Burlington Development Review Board

Development Review Board

Wednesday, March 11, 2026, 5:00 PM

To: Development Review Board
From: Mary O'Neil, AICP, Principal Planner
Date: March 11, 2026
RE: 633 Main Street; ZP-26-50

**2ED FLOOR
 LONG TERM BICYCLE STORAGE
 (2 BIKES)**

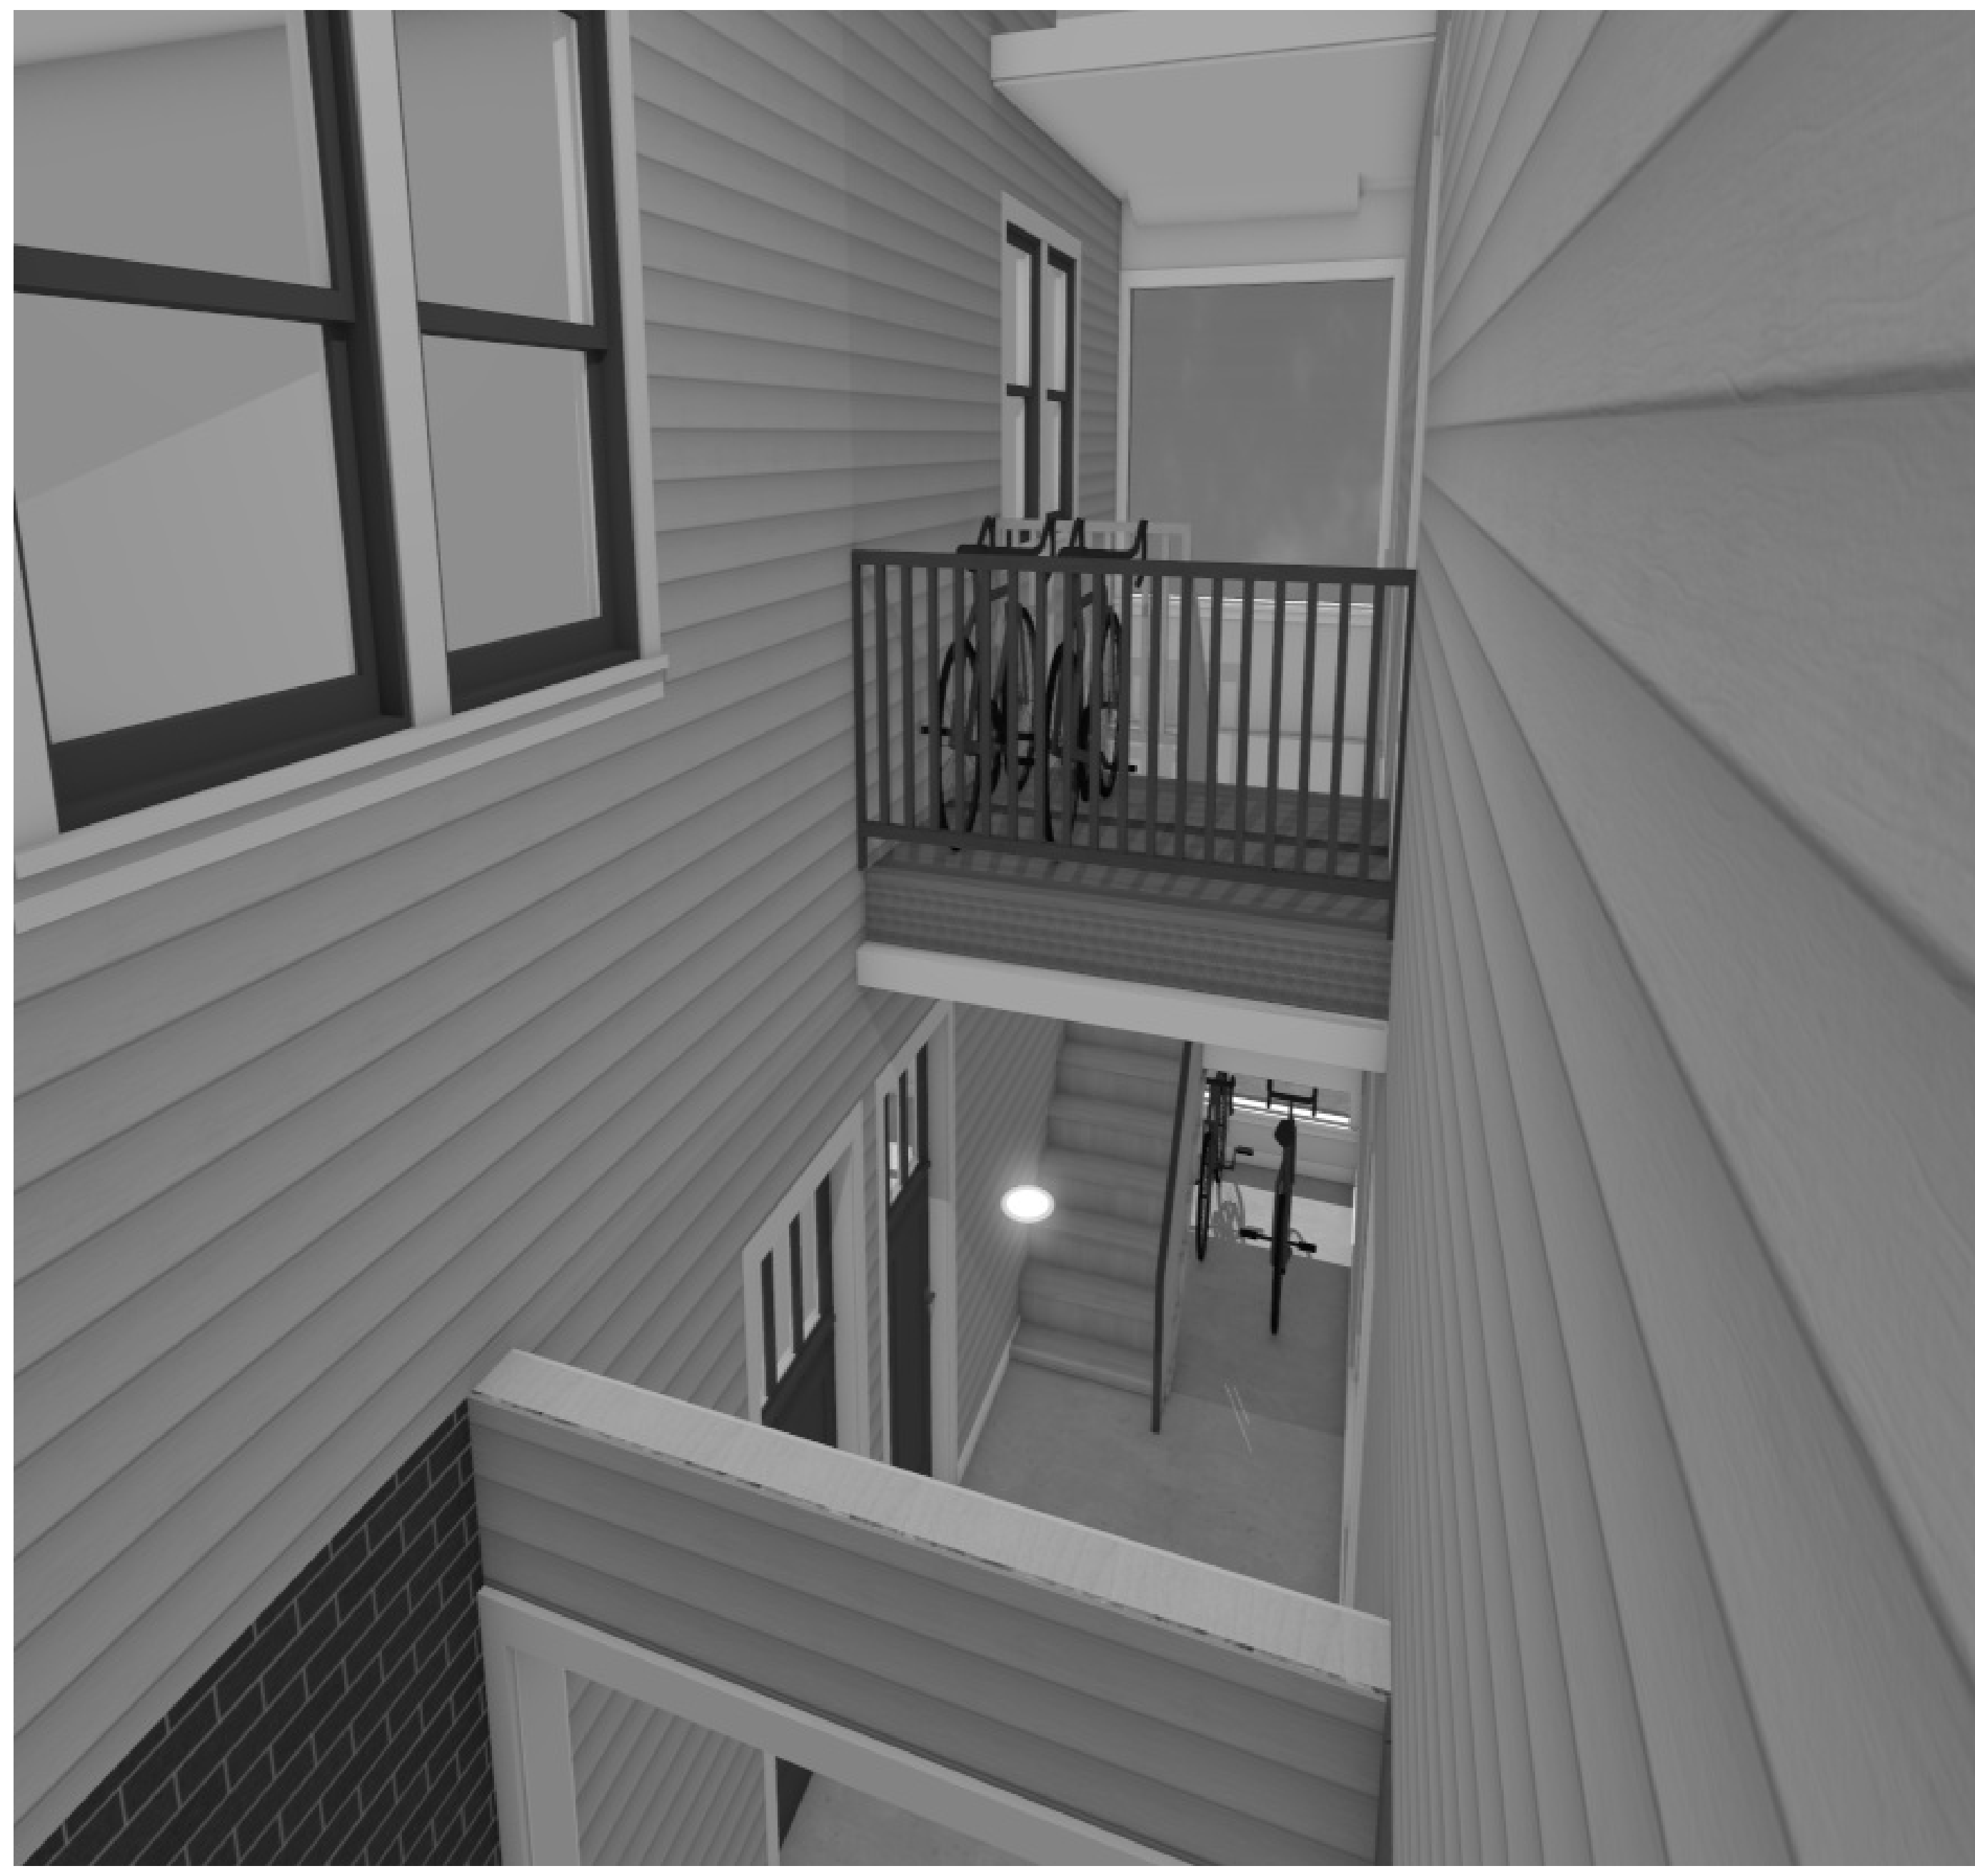
- The proposed development is consistent with the existing development pattern, building scale, and neighborhood character (planBTV, Planning to Sustain).
- The inclusion of dedicated secure bicycle storage will serve to benefit the connectivity of the proposed development to neighborhood-serving businesses and amenities (planBTV, Neighborhood Connectivity).
- The project will manage stormwater, in part, with newly created stormwater infiltration areas onsite (Comprehensive Plan, Natural Environment Action Plan). **(Affirmative finding)**
